May 26, 1999

99-05

Approval of Healy Model 9800-1 Pressure Switch

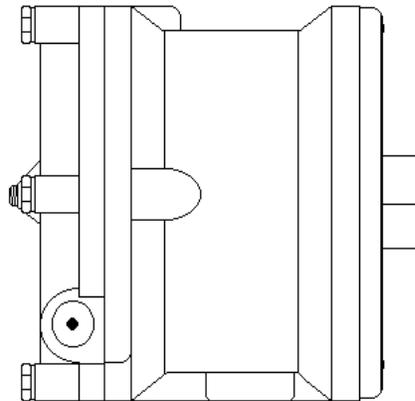
The 9800-1 Vacuum Switch is mounted on the Stage II Vapor Return line from the gasoline pumps, usually in a pit or sump on the underground tanks outside the building. At above ground installations, the switch is mounted near or on the vacuum source. Two wires (16 or 18 AWG) from the **SMCB** exit the building through a sealed conduit (per NEC). These wires must be 600 volt rated, class 1 type insulation. They connect to the two terminals, one to each terminal, without regard to which wire goes on what terminal inside the 9800-1 Vacuum Switch. See Healy Systems wiring diagram 9200-6308 (REV 4) sheets 1 and 2 for general layout and installation requirements.

I find that the use of the Healy Model 9800-1 Pressure Switch, when installed in accordance with the manufacturer's instructions and the conditions listed above, will not adversely affect the performance of the Healy Stage II vapor recovery systems utilizing a central vacuum source. Therefore, the Healy Model 9800-1 Pressure Switch is certified for use with Healy Stage II vapor recovery systems utilizing central vacuum sources as specified in Executive Orders G-70-165 and G-70-186.
